Technical Note TN-643
**Changes to T3002
Fast Charger Contacts.**

26th October 2000

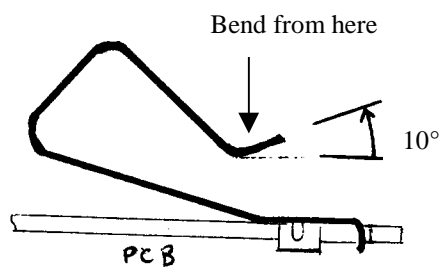
Tait Mechanical engineers investigated the issue. It was reported that the end of the charger contact itself was getting snagged / caught on the gold rivet holding the charger contact in place.

The Mechanical team decided to make a modification to allow the end of the charger contact to slide over the gold rivet, thus preventing any snagging.

- Take the existing T3002 charger contact and bend (using bull nose pliers) the indicated end up by 10°.
